E4351B-04

S E R V I C E N O T E

E4351B Solar Array Simulator

Out of specification Peak to Peak Ripple & Noise at 20 kHz

Rework On The Right Tunnel [Assembly P/N 5063-4815](#) for SAS [Model](#)

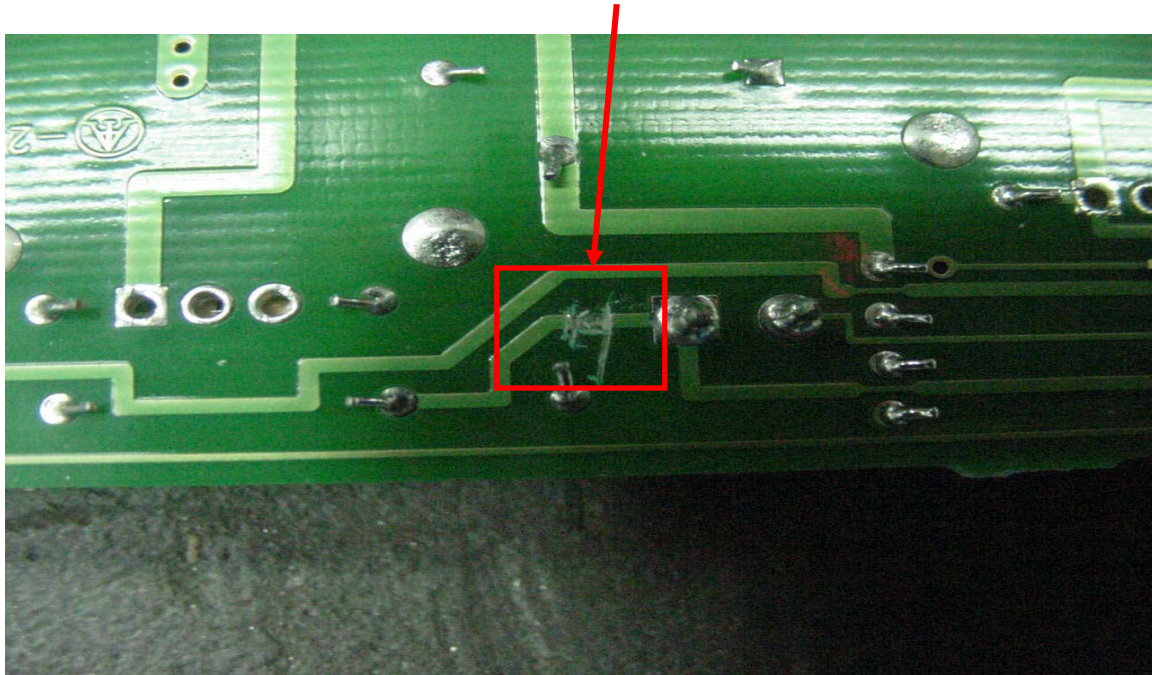
1. Figure below showing right tunnel PCA P/N 5063-4815 board ready for rework.

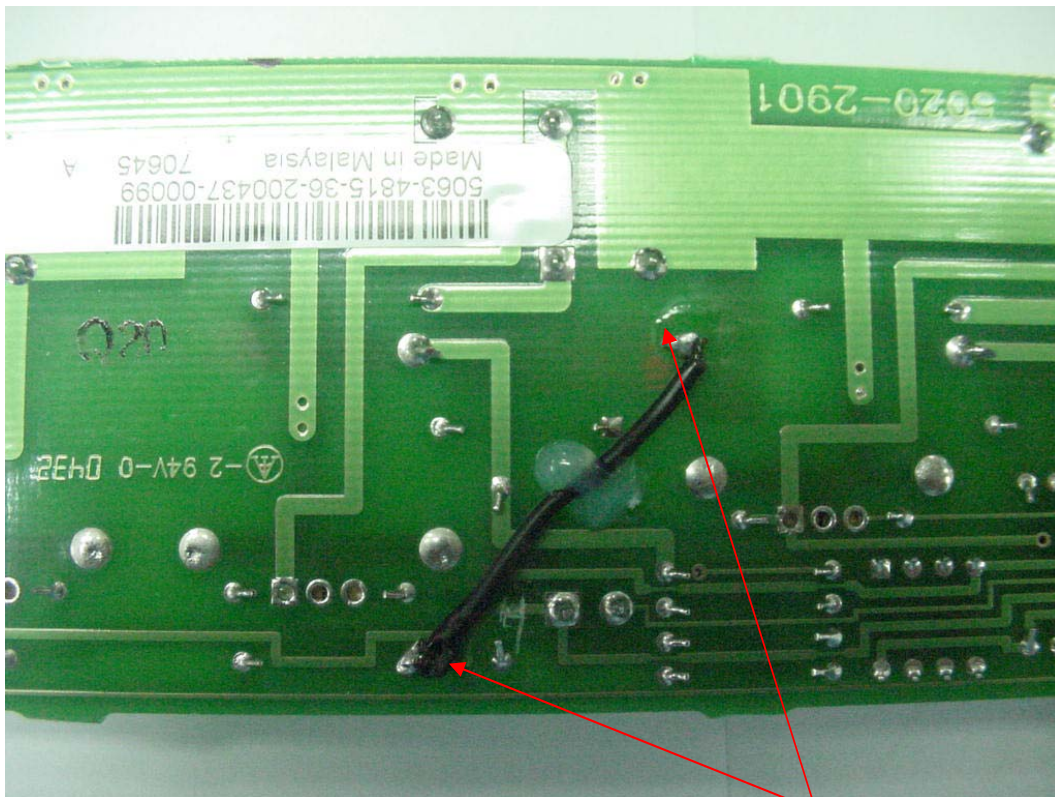
2. Cut trace between J300 and capacitor C305, on **Top and Bottom Right** side tunnel boards. **Length of trace removed should be a minimum of trace width, longer is ok.**
